VILLAS AT CLAREMONT

LETTER OF INTENT

DECEMBER 2020

LOI V_1 redlines.pdf Markup Summary 2-19-2021

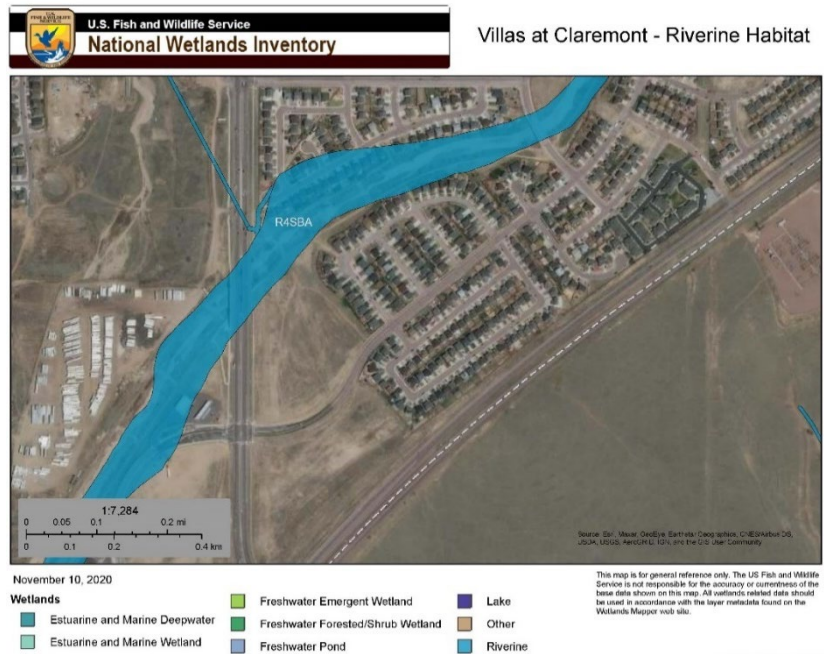
5-foot high barrier

Airport is requesting noise mitigation for construction

What is the applicant proposing? Where will it be located, who will install and maintain? Please provide a note and or detail on the PUD plan
